Amendments

In the Drawings:

Remarks

Fig. 1

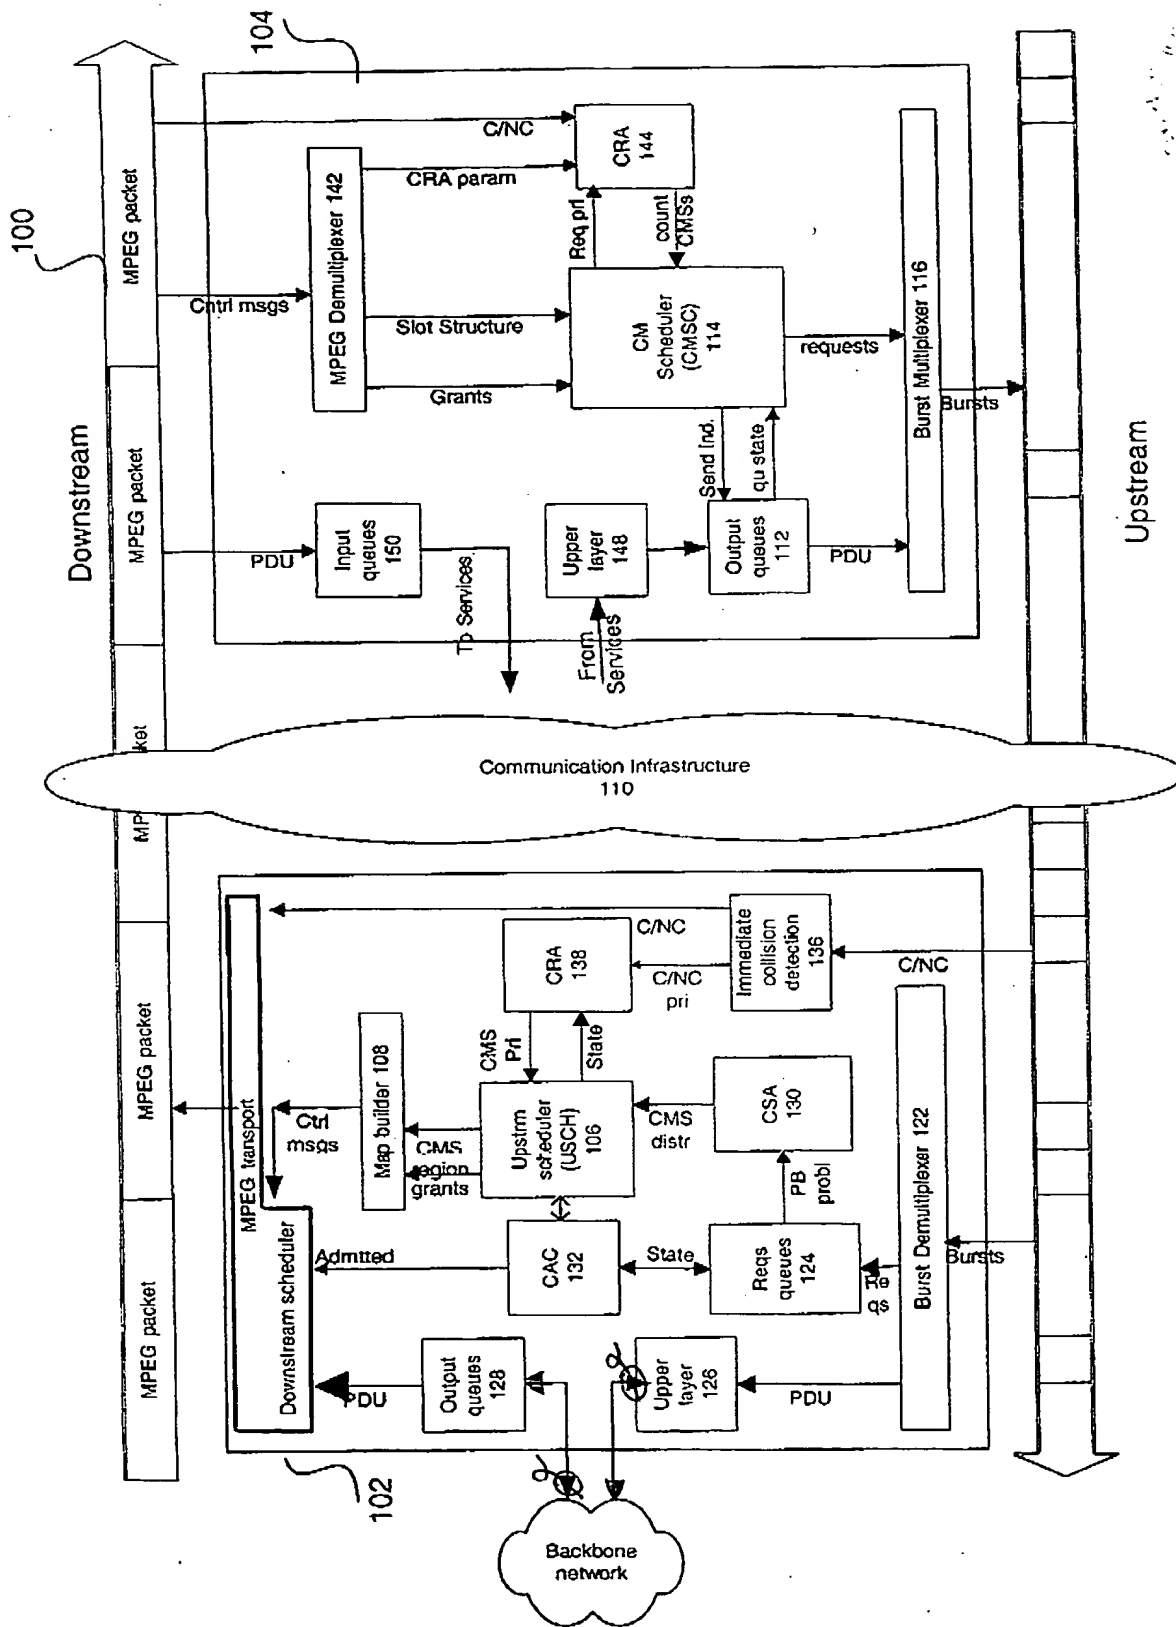
Applicants respectfully request approval of the proposed drawing changes provided herewith and illustrated in more detail in red ink on the attached Markup Copy of Figure 1. The changes to the drawing are made to rectify three obvious errors as illustrated in red ink. The first two errors pertain to the directional arrows shown therein. Referring to the pending Figure 1, Applicants assert that (1) the arrow connecting element "Upper Layer 126" to element "Backbone Network", and (2) the arrow connecting element "Backbone Network" to element "Output Queues 128" both are positioned incorrectly to depict the functional relationship among the elements. In the pending Figure 1, these arrows are reversed in the incorrect direction. Applicants further assert that no other direction for these arrows could have been intended. Therefore in the attached Figure 1, Applicants have illustrated the above-mentioned arrows in the correct

direction. The Applicants' assertions are clearly supported by the specification in paragraph 21 which describes the interrelationship of the aforementioned elements.

In addition, Applicants assert that a box outlining the element "Downstream Scheduler / MPEG Transport" is missing erroneously although the text "Downstream Scheduler / MPEG Transport" is present to label the missing box. Applicants note that several correctly boxed elements (such as, "128," "132," "108," and "136") have arrows pointing towards the element "Downstream Scheduler / MPEG Transport" to indicate the flow of signals thereto, and the element "Downstream Scheduler / MPEG Transport" also has an arrow pointing towards the element "Downstream Channel" to indicate the flow of signals thereto. Referring to the attached Figure 1, Applicants have illustrated a box to outline the element "Downstream Scheduler / MPEG Transport." The Applicants' assertions are clearly supported by paragraphs 30, 31, 32, 34, and 35 within the specification.

Please substitute the attached Figure 1 for the pending Figure 1. The attached Figure 1 is a duplicate of the drawing that is being submitted herewith as part of the Formal Drawings for Figures 1-4. The Formal Drawings are being submitted herewith under a separate pleading for approval.
